Carolina Power & Light Company

FILE: NG-3514(B)

SERIAL: GD-79-2050

BRUNSWICK STEAM ELECTRIC PLANT, UNIT NOS. 1 AND 2
DOCKET NOS. 50-325 AND 50-324
LICENSE NOS. DPR-71 AND DPR-62
REQUEST FOR LICENSE AMENDMENT - CORPORATE ORGANIZATIONAL CHANGES

MANAGEMENT ORGANIZATION CHART
Figure 5.1-1 (Prime)

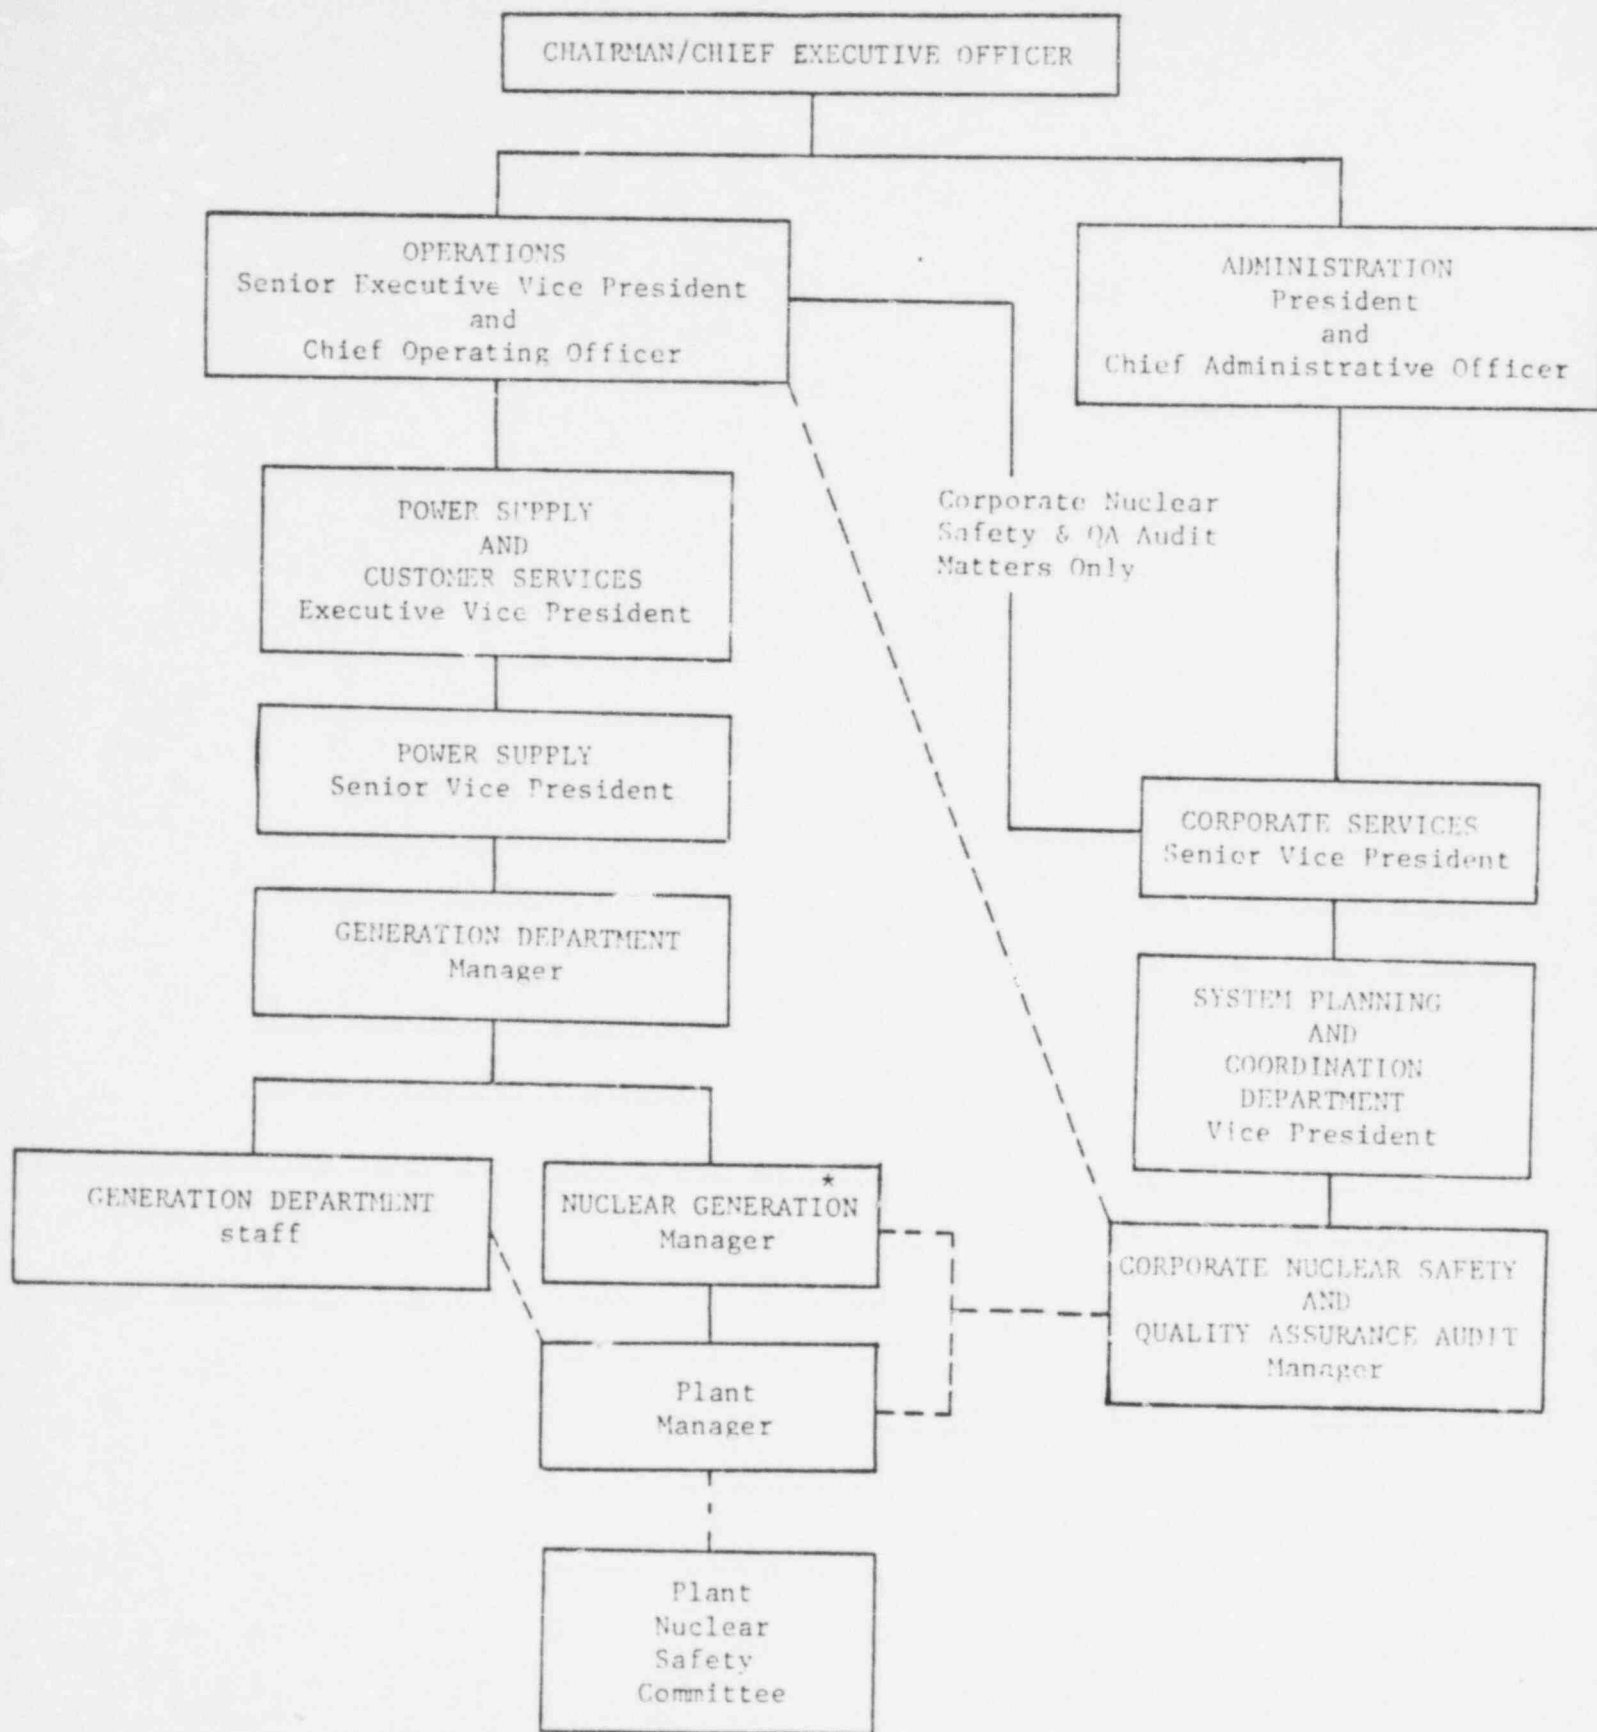
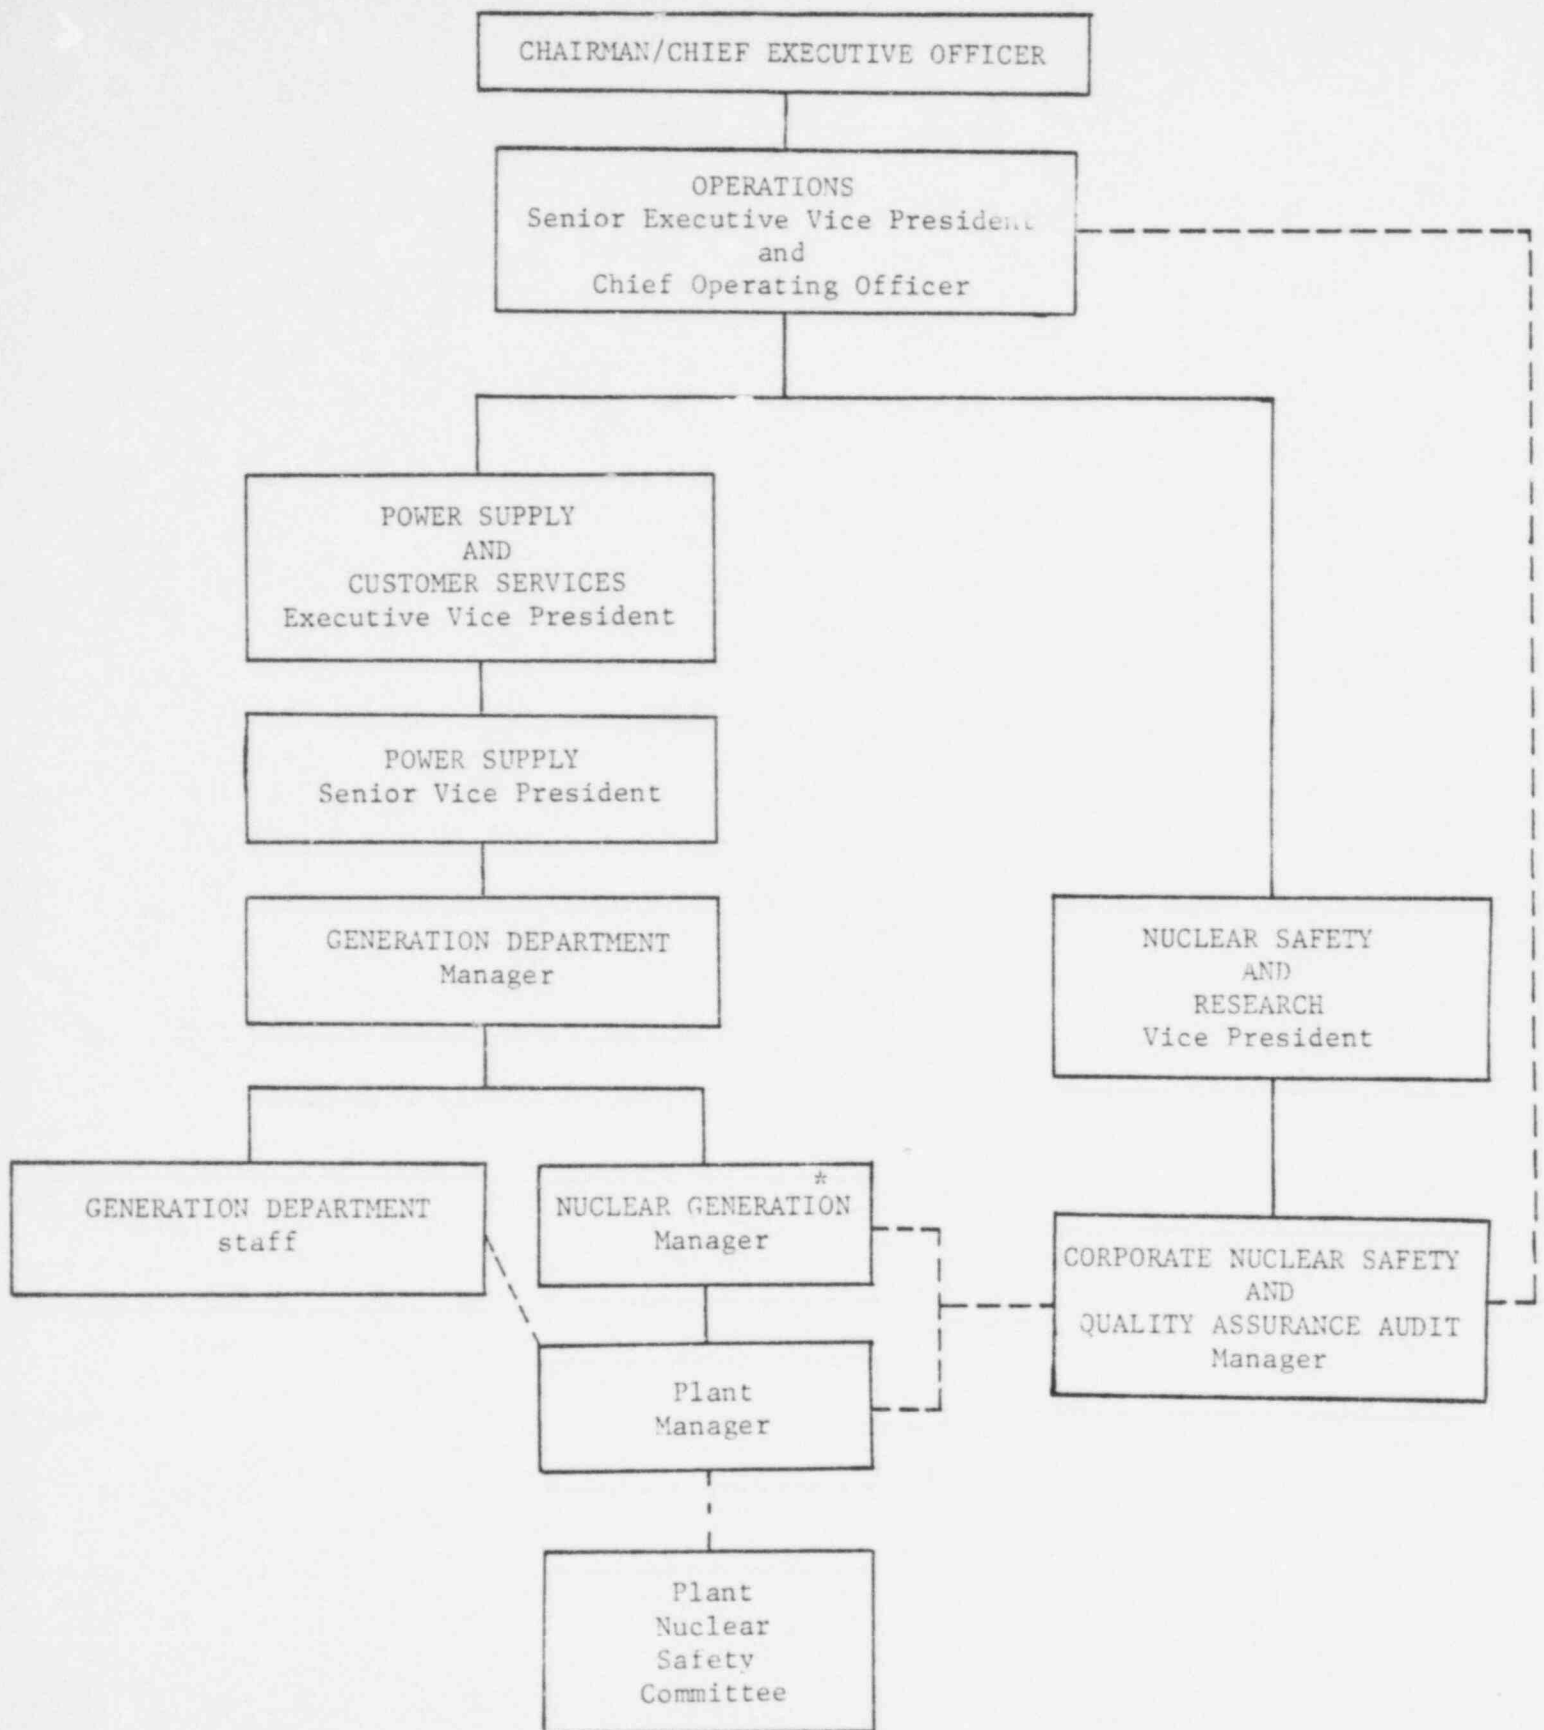
As before, Mr. J. A. Jones remains as the Chief Operating Officer for CP&L and is the addressee for official correspondence from the NRC. His title, however, is now Senior Executive Vice President. I am now Executive Vice President - Power Supply & Customer Services. My former position, Senior Vice President - Power Supply, is now held by Mr. D. V. Menscer.

The Plant Manager is directly responsible for the safe operation of the facility as shown in Figure 5.1-1(Prime). In all matters pertaining to the operation of the plant and to the Environmental Technical Specifications, the Plant Manager is directly responsible to the Manager of Nuclear Generation. The Environmental and Radiation Control Supervisor is directly responsible to the Plant Manager for all Environmental Technical Specifications applicable to the plant, radiological and otherwise.
